**Permit Application Review Report**  
**Date: 4/22/2026**

**Project Name:** SP 0217-36 TH610 and East River Road Interchange

**Project PAN:** P-25-033

**Recommendation:** Approve with 1 Condition and 4 Stipulations

# Figure 2: Site Plan

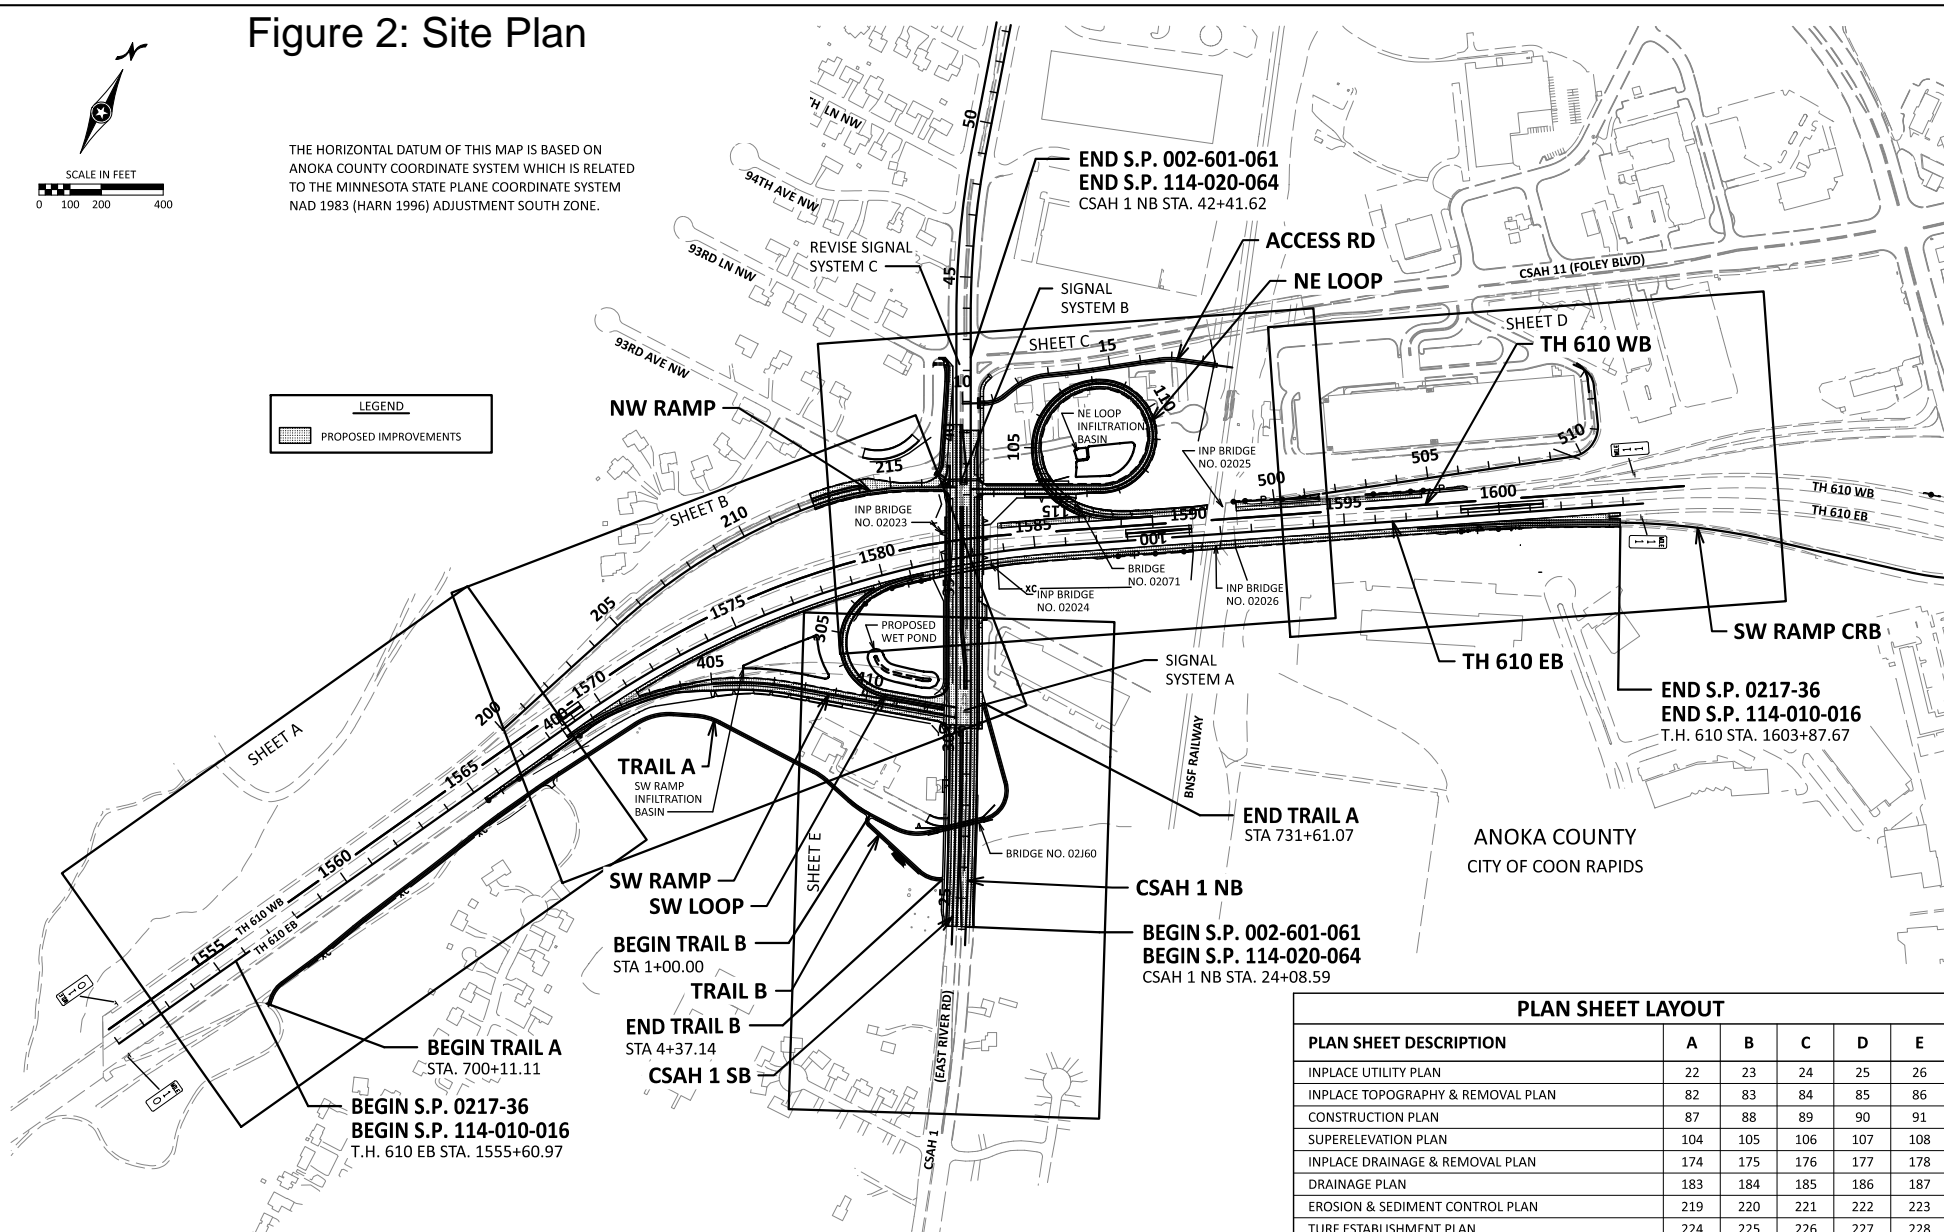
**Description:** The City of Coon Rapids is proposing the reconstruction and reconfigurations of the Hwy 610 and East River Road interchange. The project will include two new loop ramp entrances, bridge widening, trail realignment and pedestrian underpass, as well as associated stormwater treatment features. The project will disturb 30.98 acres and create 11.11 acres of regulated impervious surface. The relevant water resource concerns are stormwater management, soils and erosion control, and wetlands which correspond to District Rules 3, 4, and 5. See attached Figure 1: Project Location and Figure 2: Site Plan.

# Figure 3: Erosion and Sediment Control Plan

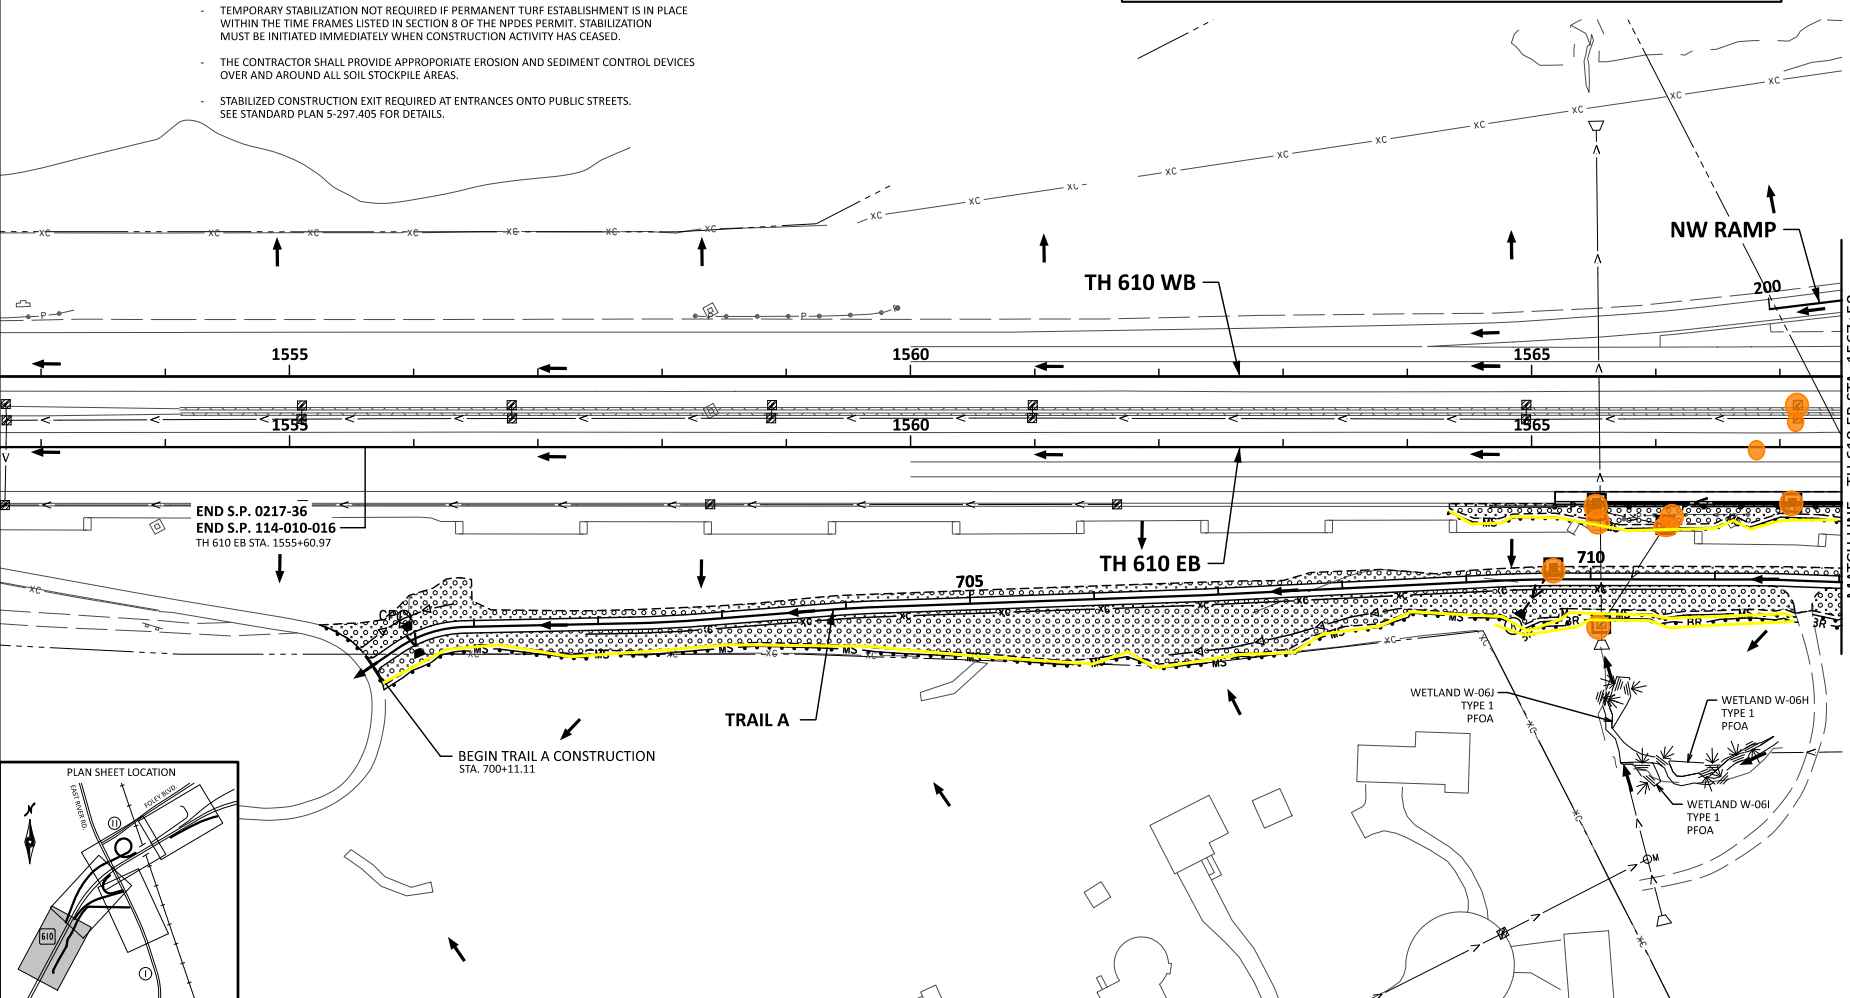
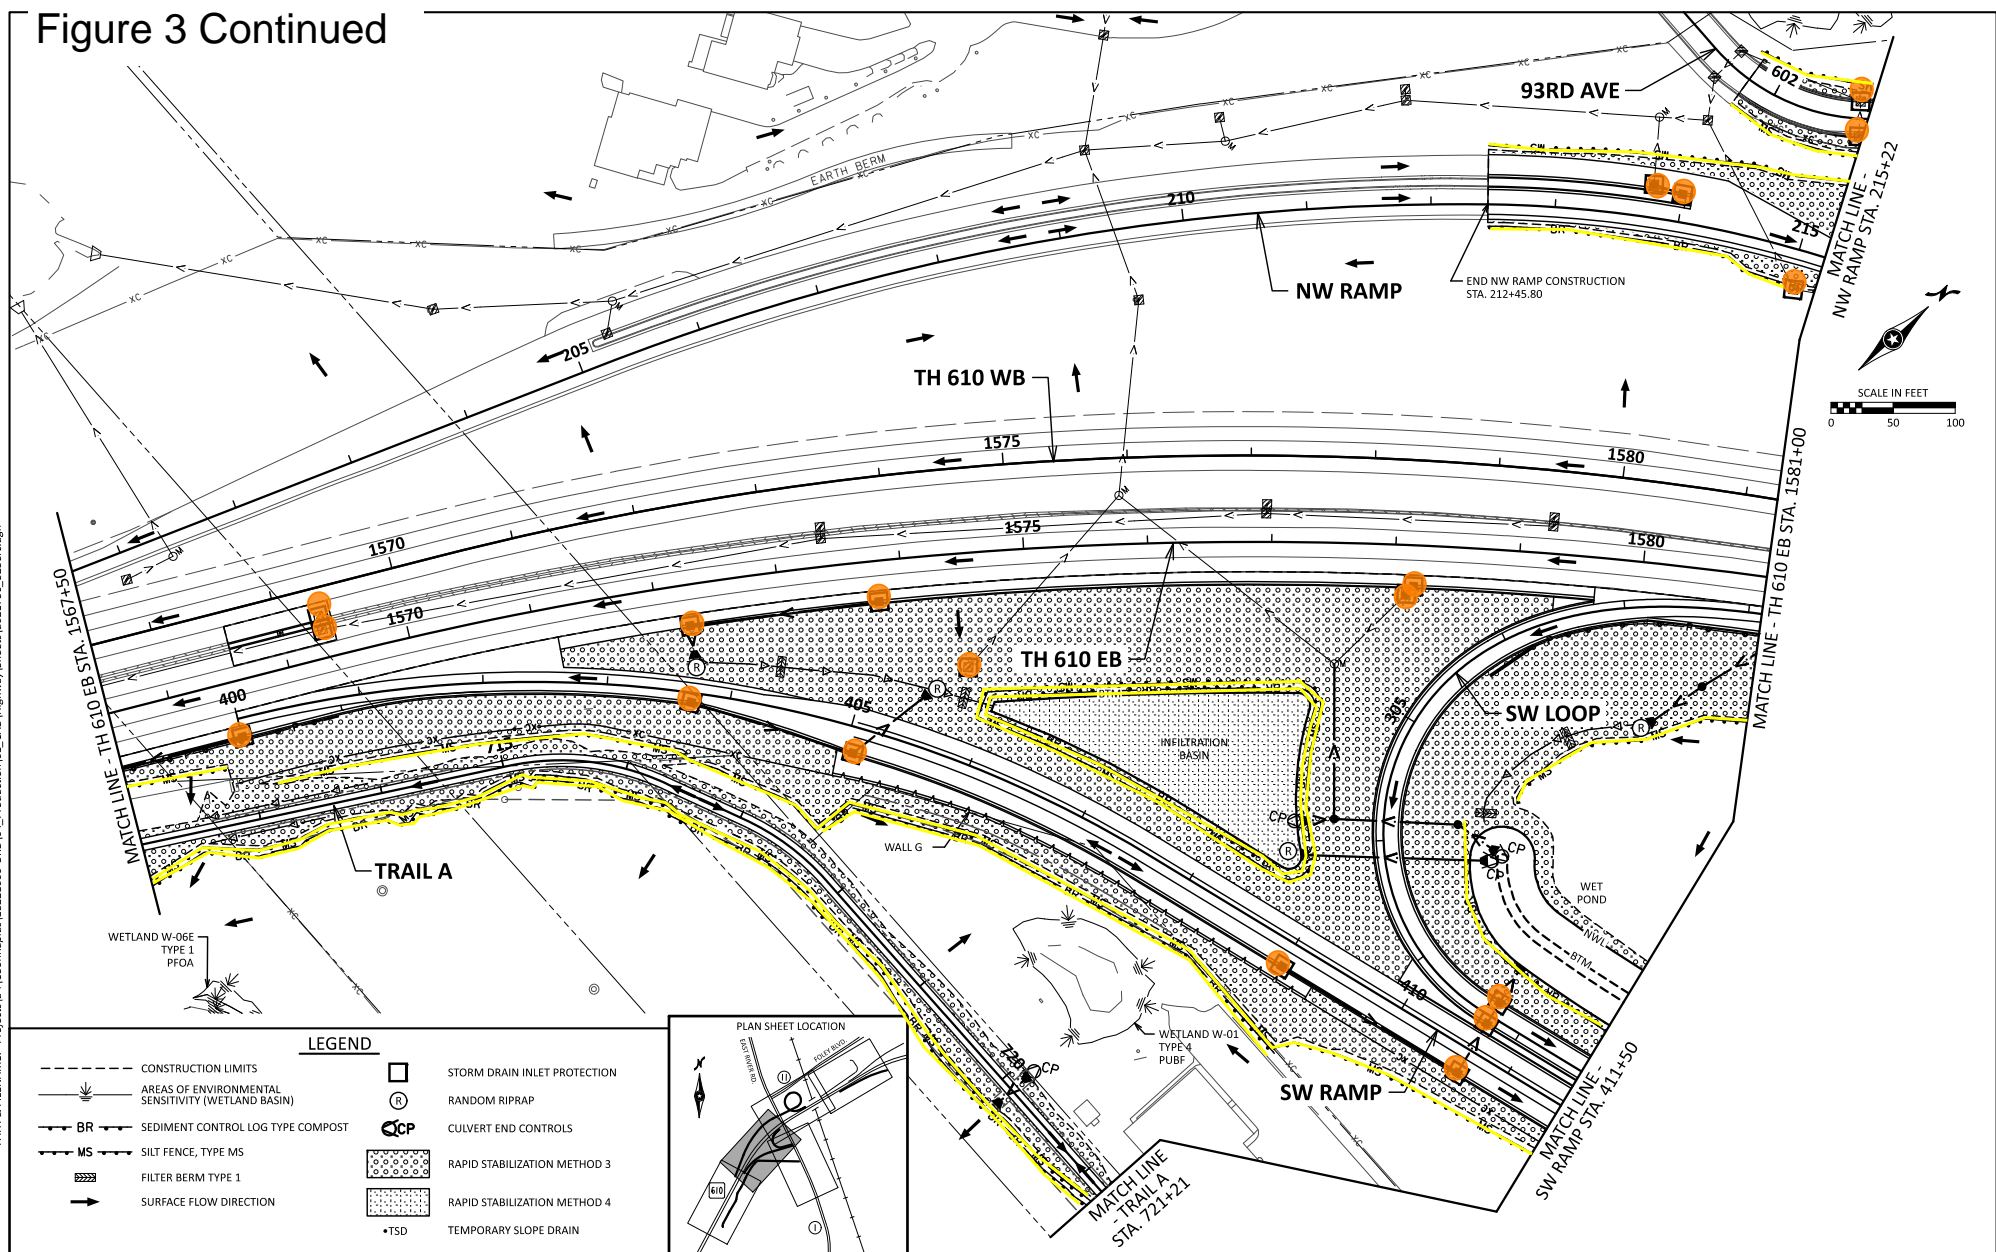
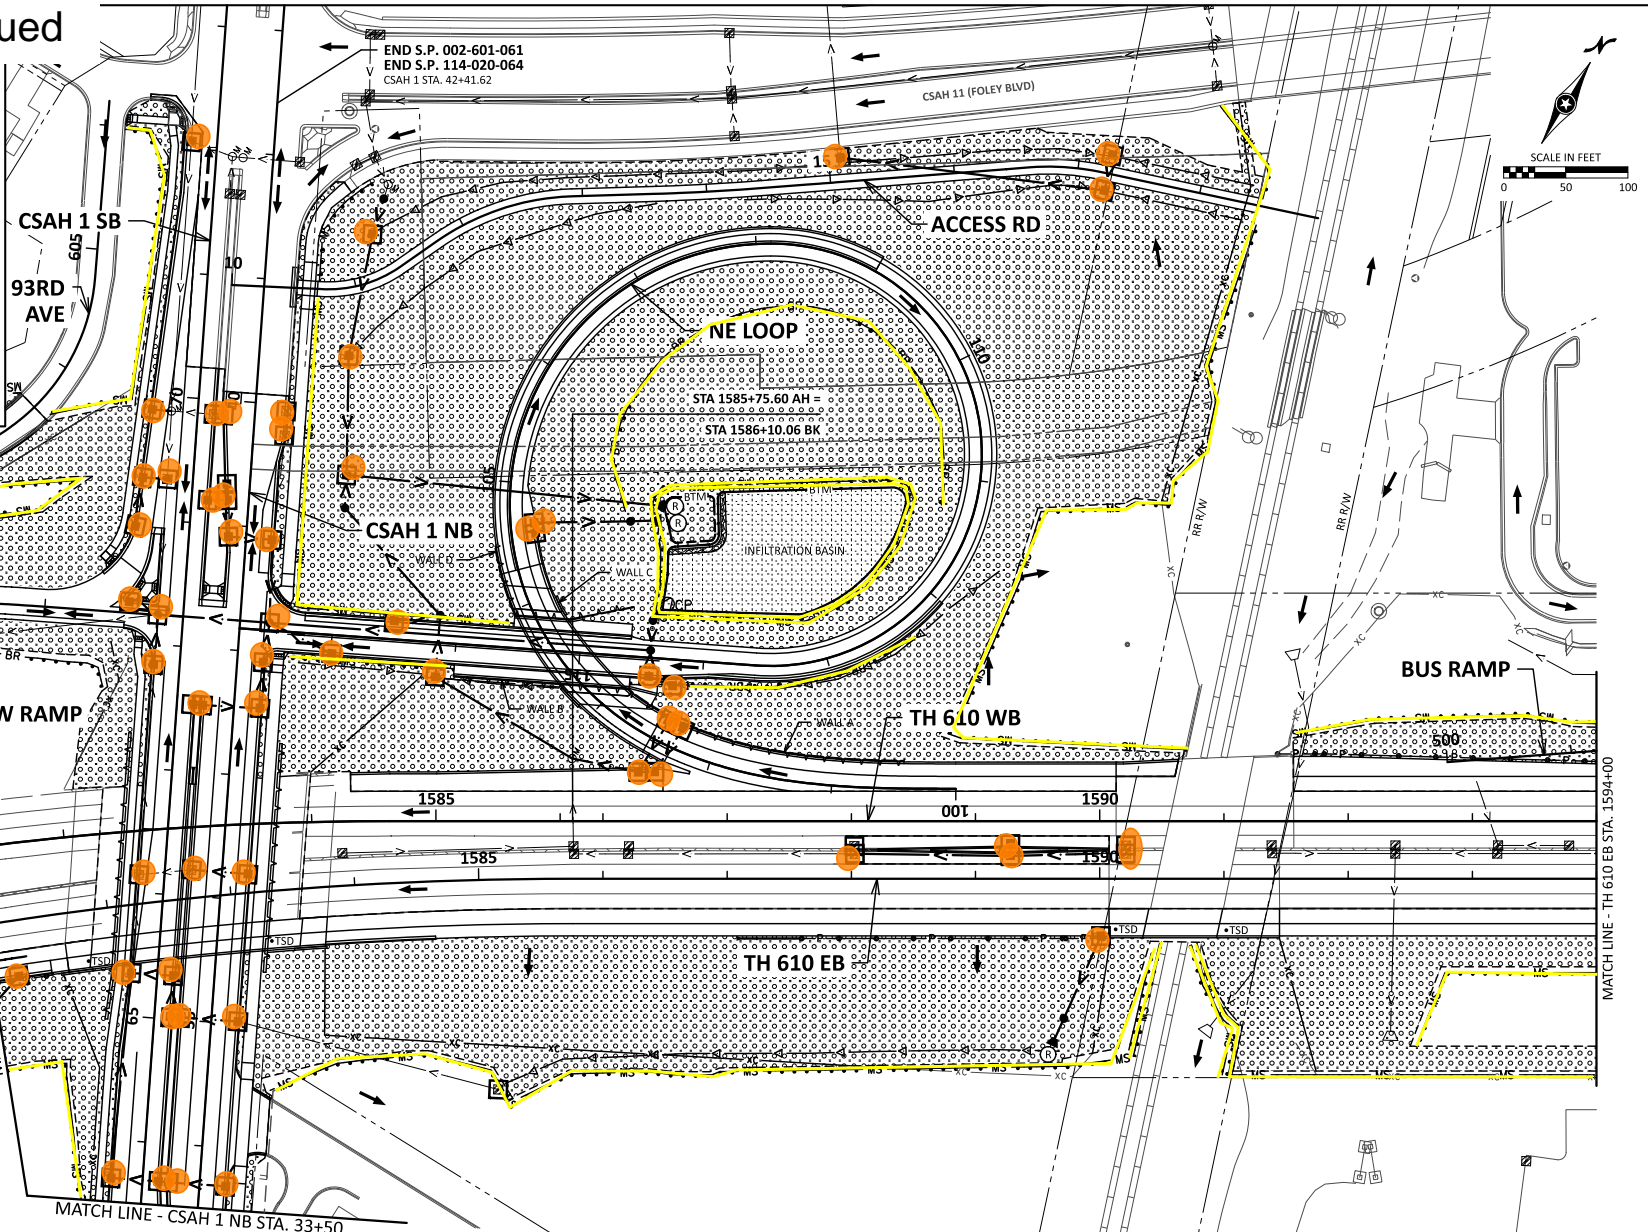
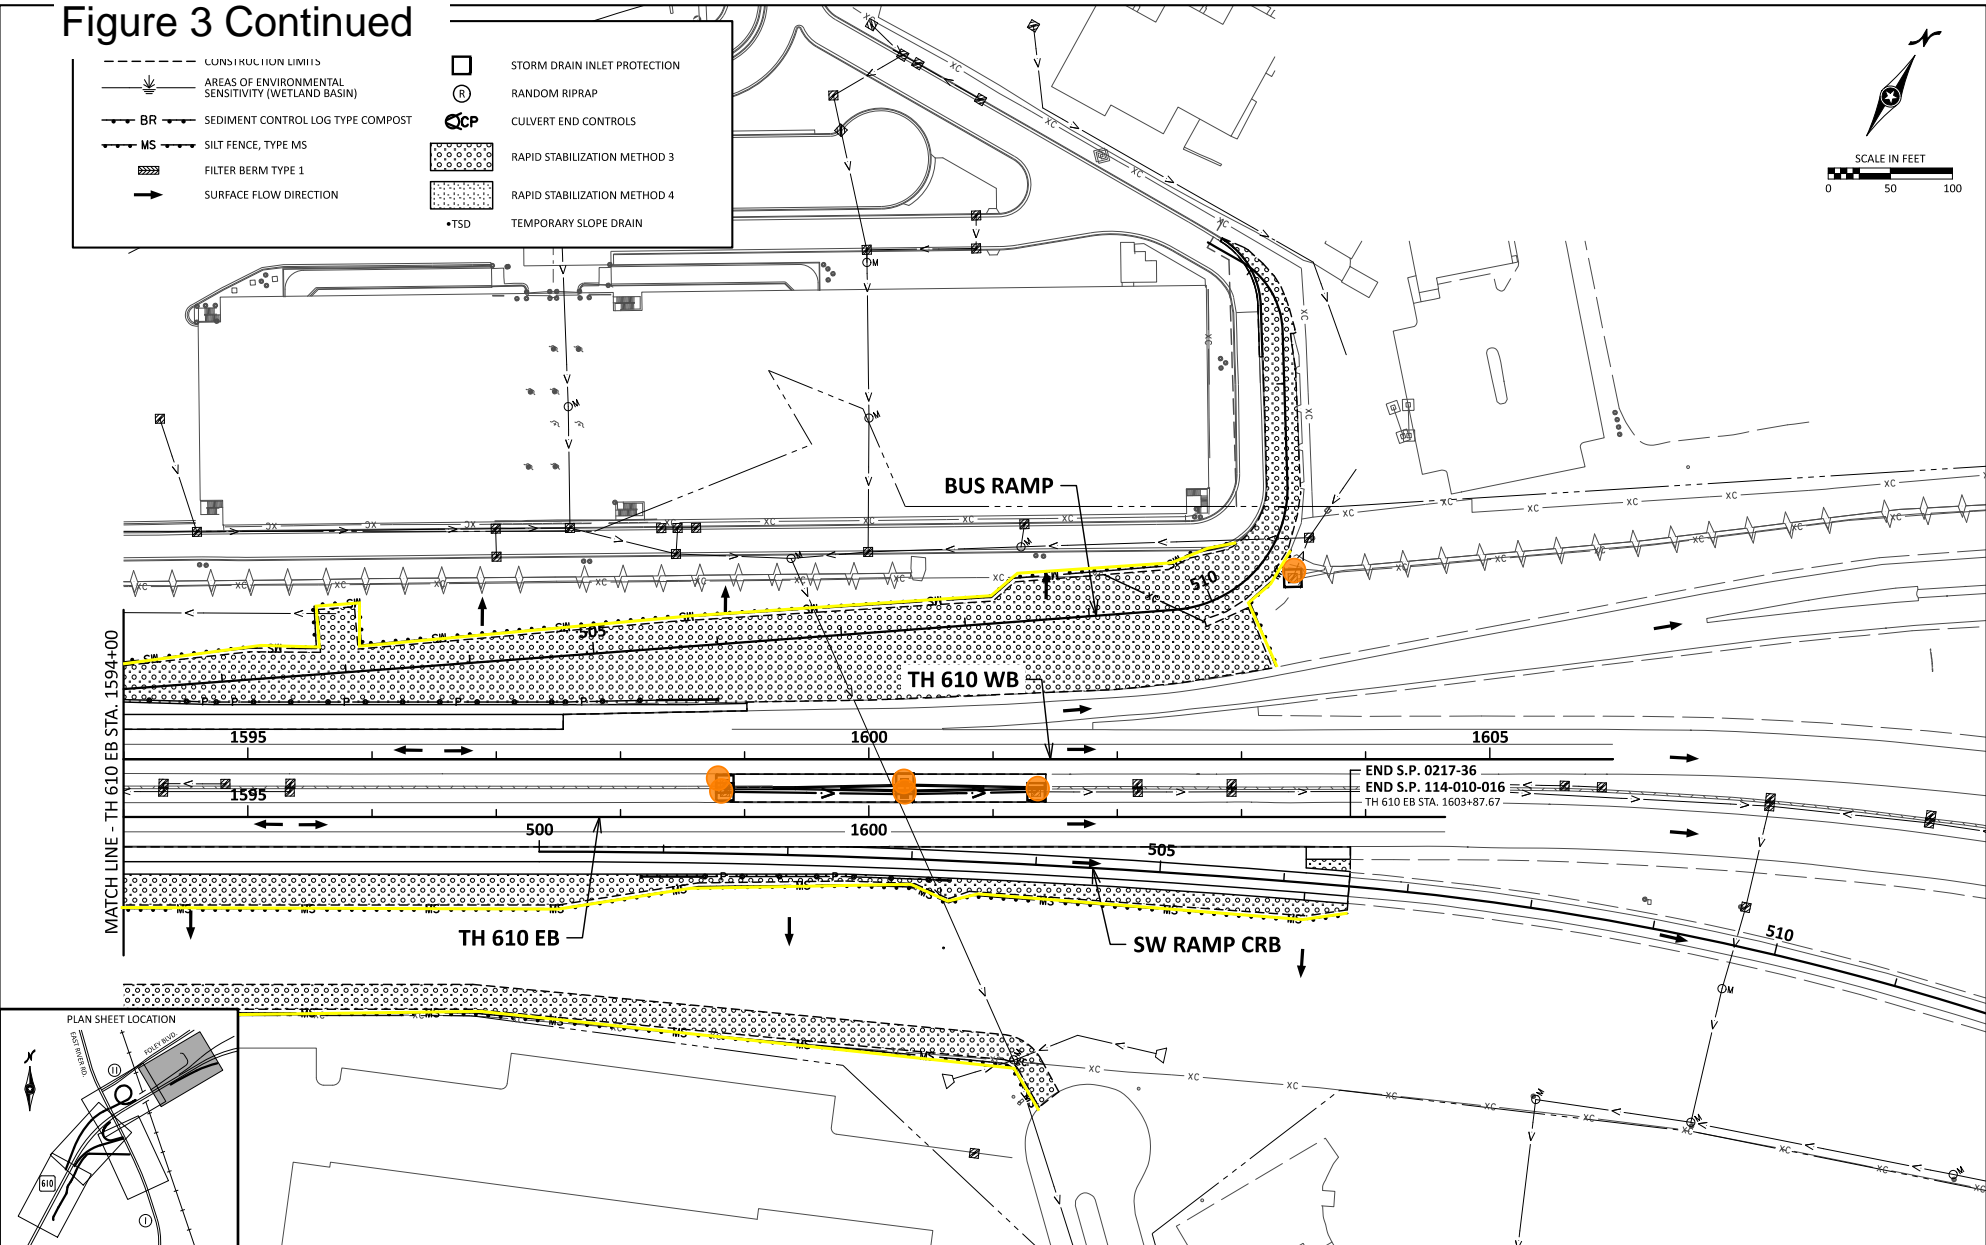
Portions of the proposed project drains to Lower Coon Creek and Pleasure Creek. The soils affected by the project includes Zimmerman and has a soil erodibility factor of 0.15 or greater. Disturbed areas are proposed to be stabilized within 7 days, as required. The proposed erosion and sediment control plan includes inlet protection, perimeter control, stabilized construction entrance, and street sweeping. The erosion control plan meets District requirements. The site does require an NPDES permit. See attached Figure 3: Erosion and Sediment Control Plan.
